ADDRESS: 4370-74 MAIN ST

Proposal: Construct two-story addition

Review: In Concept

SCOPE OF WORK:

2 A-2 PROPOSED REAR ELEVATION - SCHUYLKILL RIVER TRAIL
Scale: 1/4" = 1'-0"

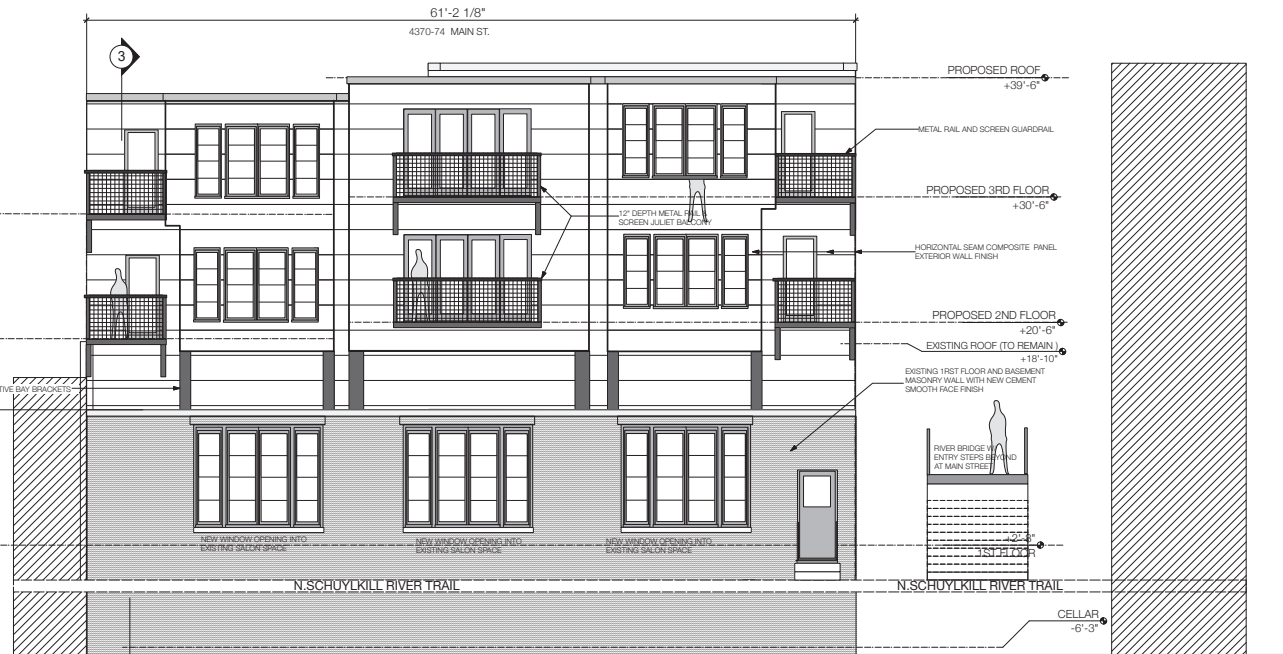
The combined building’s rear façade faces the Schuylkill River Trail with substantial public visibility. Significant changes are proposed to the existing rear façade. The application proposes a completely new fenestration pattern to align the four window bays proposed for the second and third floors above, suggesting infill of existing windows and/or expansion of window openings.

similar or industrial appearances in the rear. The proposed alterations to the existing rear façade may detract from the historic character of the district.

STAFF RECOMMENDATION: Approval of the overall size, massing, and general design of the proposed additions, but denial based on the need for additional details about materials, colors, finishes, and the proposed alterations to the rear façade, pursuant to Standards 2, 9, and 10, and Main Street Manayunk review criteria.

- The proposal maintains the historic storefront’s features, satisfying Standard 2, but the proposal lacks detail regarding how the addition interacts with the wall above the cornice on the front façade.

- *Standard 10: New additions and adjacent or related new construction will be undertaken in such a manner that, if removed in the future, the essential form and integrity of the historic property and its environment would be unimpaired.*
 - The proposed addition maintains the appearance of the front façade, though more detail on the interaction between the second-floor addition and front parapet on the contributing building is needed to determine if the application satisfies Standard 10.
